<b>XtremeAir GmbH, Harzstr.2, D-39444 Hecklingen</b> Tel: +49 39267 60999 0, Fax: +49 39267 60999 20 www.xtremeair.de info@xtremeair.de	Document No. <b>SB-2012-004</b>
		Issue: A.02
DOA-Nr.: EASA.21J.360	<b>Service Bulletin SB-2012-004</b>	Date: 16.07.2013

Subject:	Tailwheel lock (TWL)
Aircraft type affected:	XA41 & XA42
Serial numbers affected:	01-06 and 101-114
Compliance:	Optional
Time of Compliance:	At operator's discretion
Purpose:	To notify owners of the option to install a tail wheel lock.
Background:	The tail wheel lock will offer an improved directional control during taxi and landing roll. This present service bulletin describes the measure to install this tail wheel lock.
Manpower:	It is estimated approximately six (6) to eight (8) man-hours will be required to accomplish this bulletin.
Materials:	The following parts kit should be ordered through <a href="mailto:spares@xtremeair.de">spares@xtremeair.de</a> :  (1) Kit AM-2011-066 (1) Aircraft Flight Manual Supplement
	The following consumables are required:  - Inspection lacquer, e.g. "Torque Seal" - Araldite 2022 adhesive
Weight and Balance:	weight: 885 g (1.95 lbs.) Arm: XA41: 3470 mm (136.61") XA42: 3720 mm (146.46")

**Figure 1: Installation Tail Wheel Strut (Einbaurichtung = Bolt Orientation)**

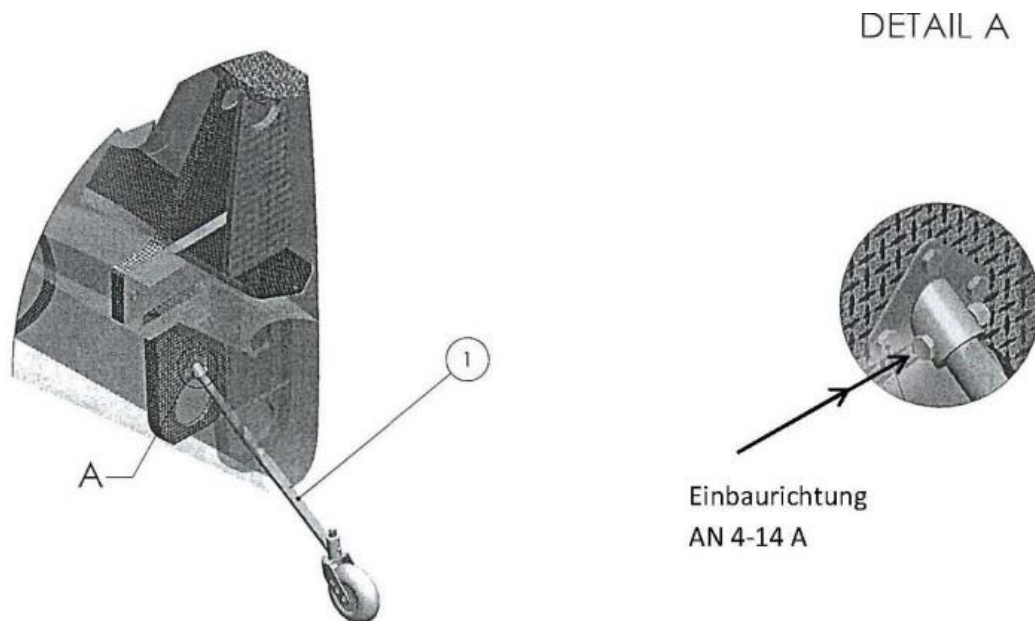
1. Replace existing Tail Wheel Assembly XA42-3230-051 with P/N XA42-3260-001: (see Figure 1)
  - a. Remove AN4-14 A bolt at Tail Wheel Mounting Bracket on the Fuselage Rear Spar and withdraw the Tail Wheel Assembly.
  - b. Place the new assembly into the Mounting Bracket.

- c. Insert AN4-14A bolt from left to right, torque using a new MS24044N4 Nut and seal thread with inspection lacquer.
2. Remove the Rear Seat from the cockpit.

Figure 2: Position of Bowden Cable

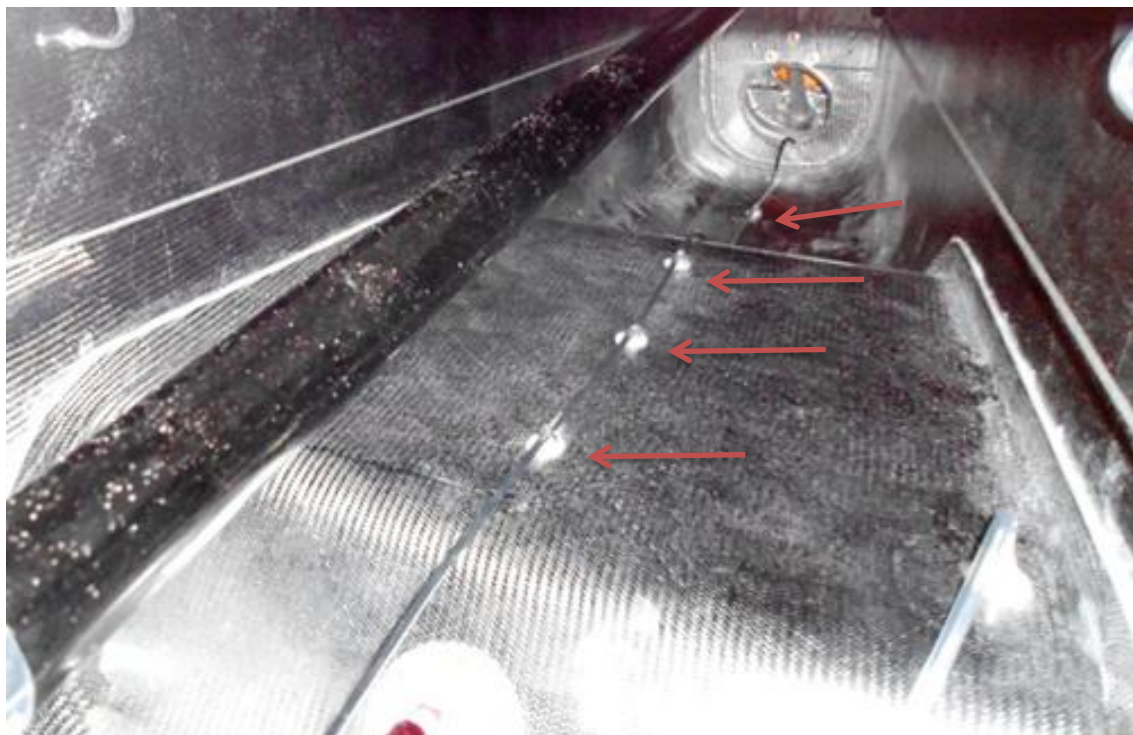
3. Bond the Cable Mounting Bases on the fuselage floor and smoke tank (see Figure 2) using Araldite 2022.
4. Insert the preassembled Bowden Cable through the Fuselage Rear Spar and fix it to the Cable Mounting Bases with Tie Wraps.

Figure 3: Principle of Control Assembly

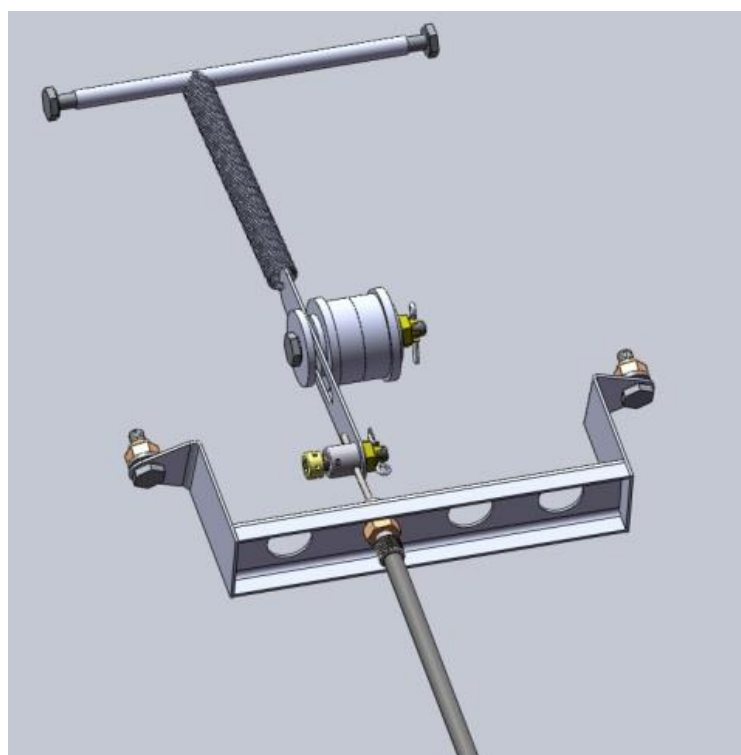
5. Install the Tail wheel Lock Control Assembly XA42-3261-001 on Seat Spar and Elevator Bell Crank XA42-2730-100, see Figure 3 to Figure 7:
  - a. Position TWL Cable Bracket XA 42-3261-100 at seat spar as shown on Figure 4. Drill 2 holes, diameter 4,8mm, and attach the bracket with 2 ea. Bolt AN3-3A, Washer AN960-10 and Lock Nut MS21044N3.

Figure 4: TWL control assembly installation 1/2

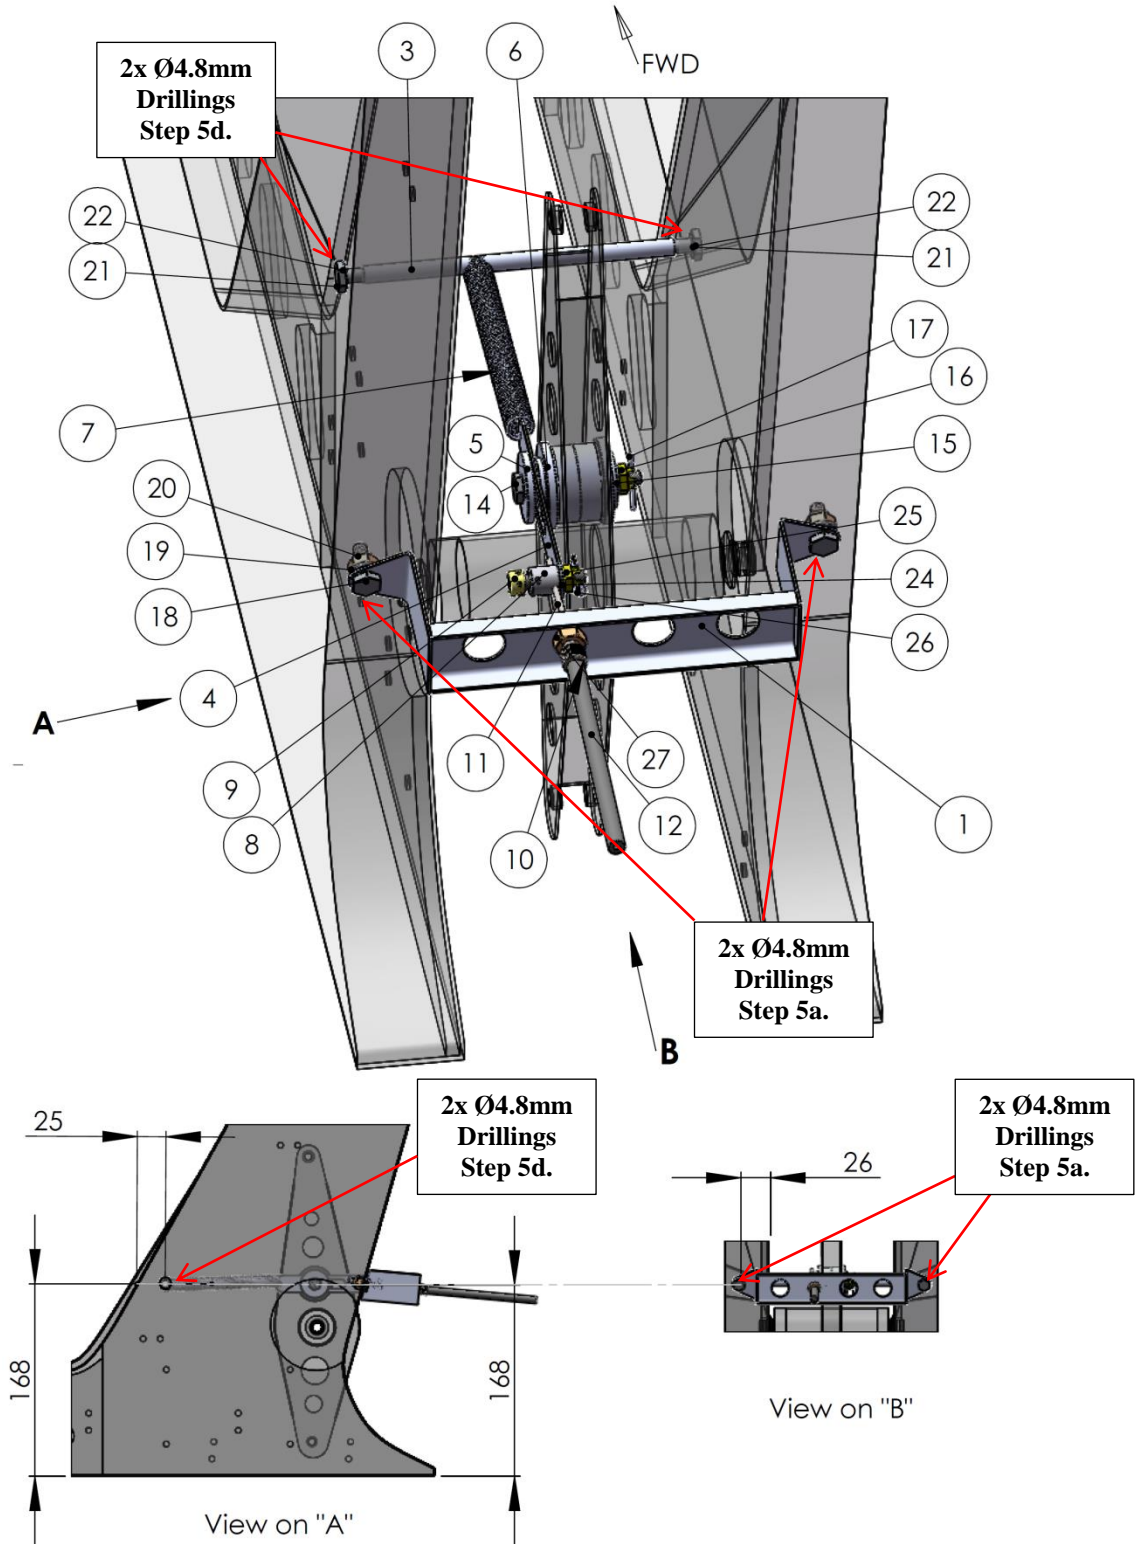
- b. Insert 2 ea. TWL Idler Bushings XA42-3261-206 into Elevator Bell Crank XA42-2730-100.
  - c. Install TWL Slider Bushing XA42-3261-205 and TWL Slotted Link XA42-3261-204 from the left hand side to the TWL Idler Bushings using Bolt AN3-15, Washer AN 960-10, castle nut AN310-03, and Cotter Pin, see Figure 4 and 5.

- d. Drill 4,8 mm diameter holes through the L/H and R/H seat spars as shown on Figure 4.
  - e. Install TWL Spring Retainer XA42-3261-203 using 2 ea. AN3-5A Bolts and AN960-10L Washers. Seal bolt heads with inspection lacquer.

Figure 8: Elevator position

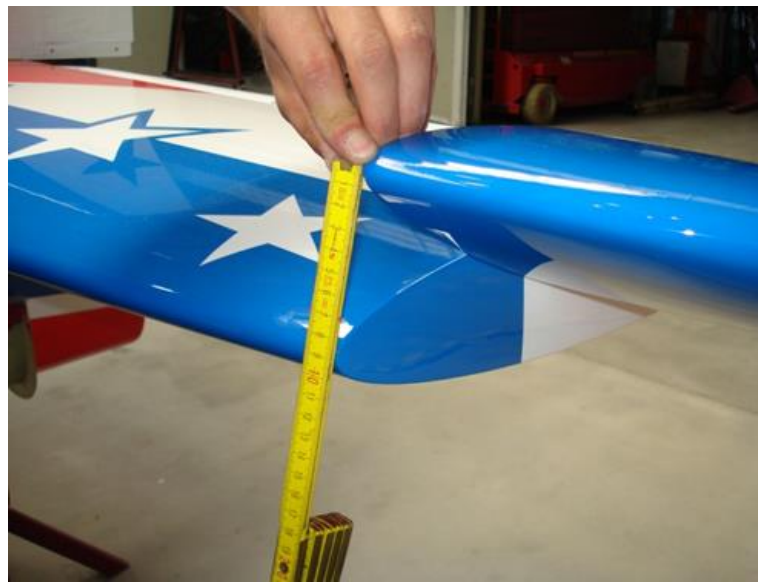
- h. Lift the elevator leading edge 90mm and temporarily fix it in this position, see Figure 8.
  - i. Insert the forward end of Bowden Inner Cable into TWL Clamp Shell XA42-3261-208 and fix with Screw XA42-6110-205. Secure with safety wire.
